## Browns Summit Creek Restoration Project Year 2 Monitoring Report

DMS Project ID No. 96313, DEQ Contract No. 5792

Subject: Response to Task 8 Draft Year 2 Monitoring Report Comments for Brown's Summit  
(DMS #96313) Cape Fear River Basin; CU 03030002; Guilford County, North  
Carolina Contract No.005792

**Figure 4.2**  
**Current Conditions**  
**Plan View**  
**Browns Summit Site**  
**(DMS #96313)**

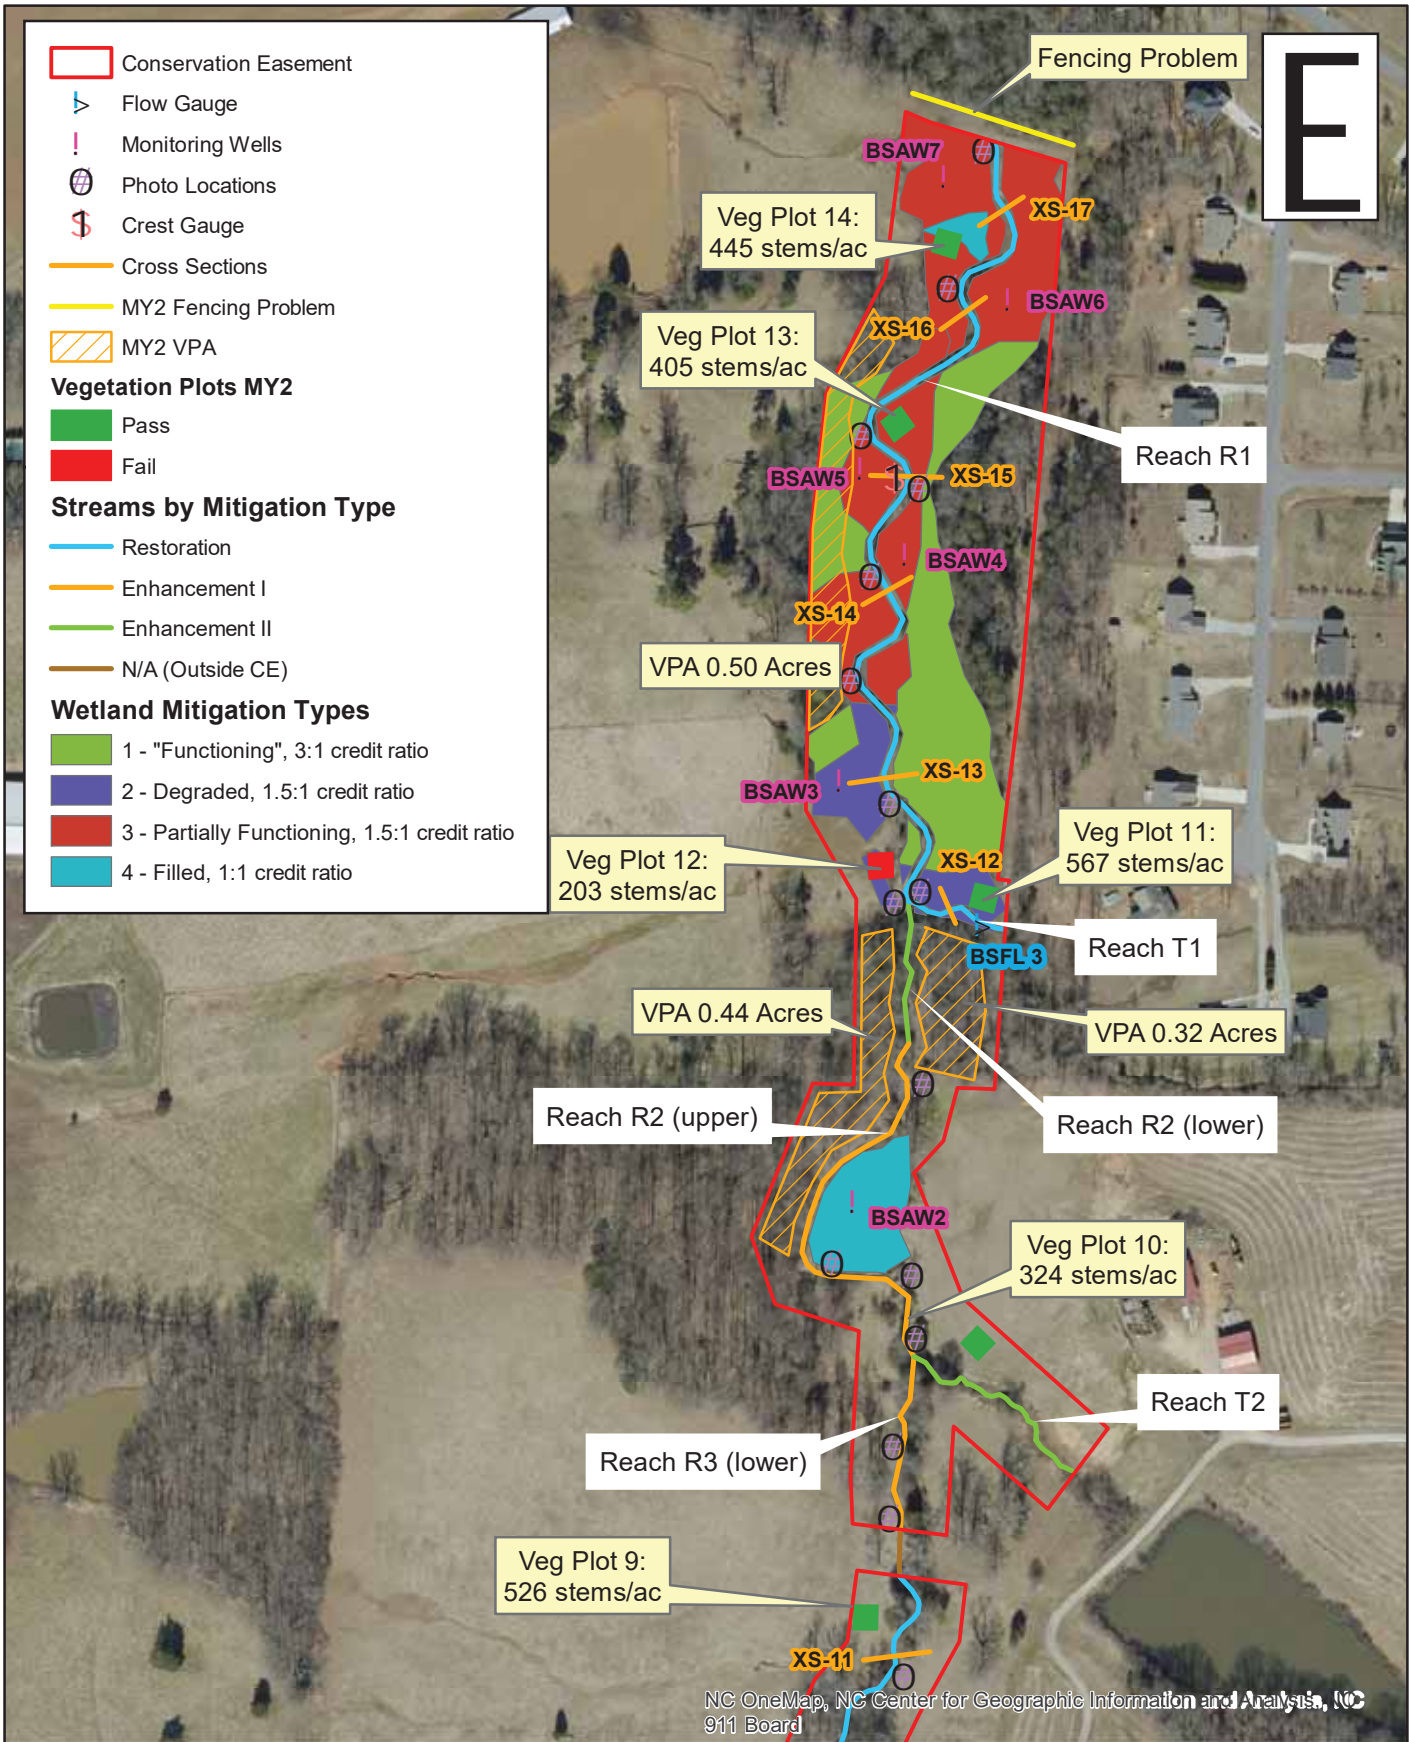
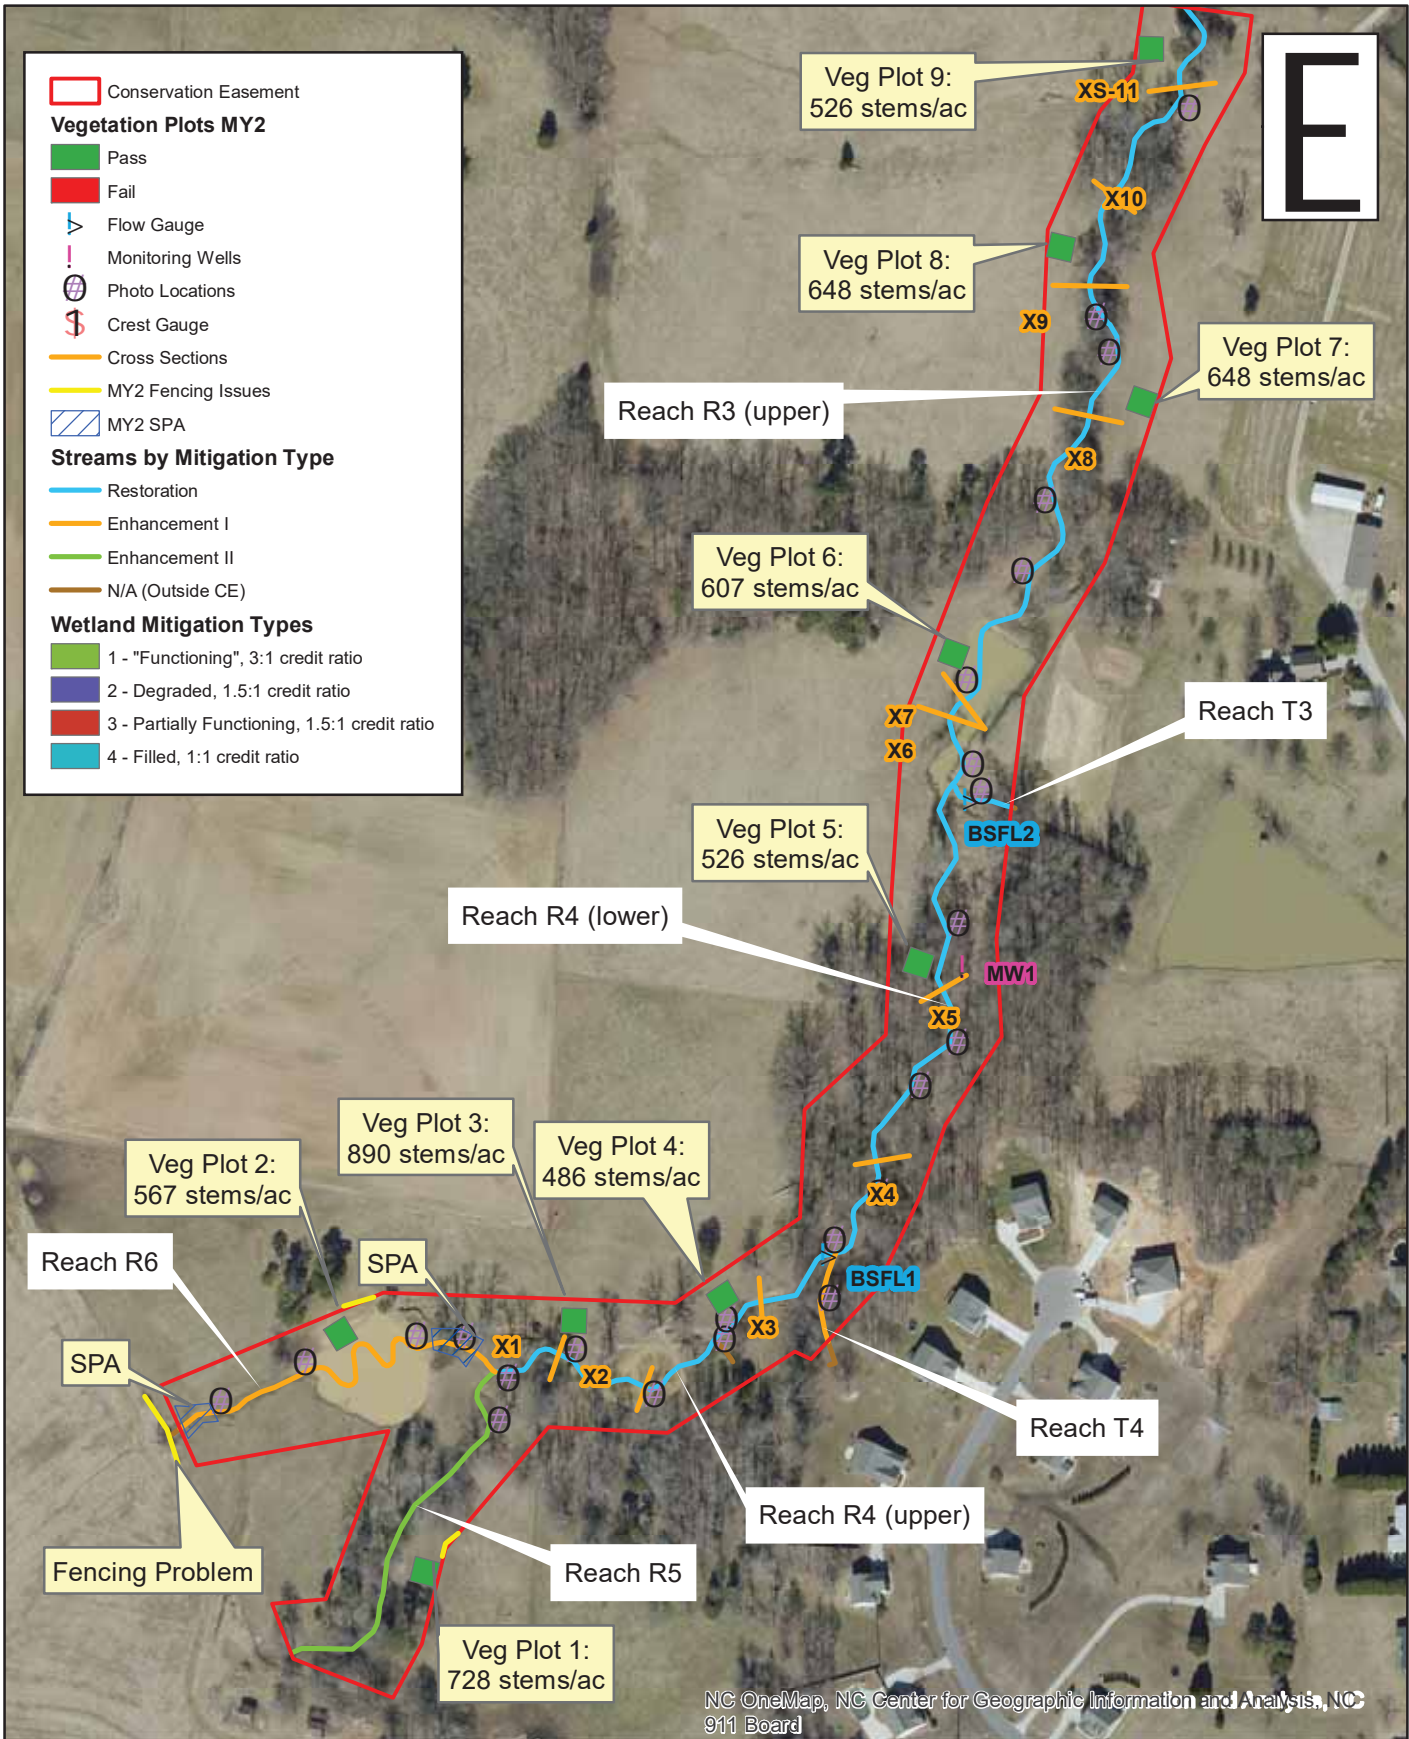
5. Appendix B, CCPV: Section 2.1.4 references two stream problem areas (SPAs). Please point these areas out on the CCPV.

***Response: The CCPV has been revised per comment above.***
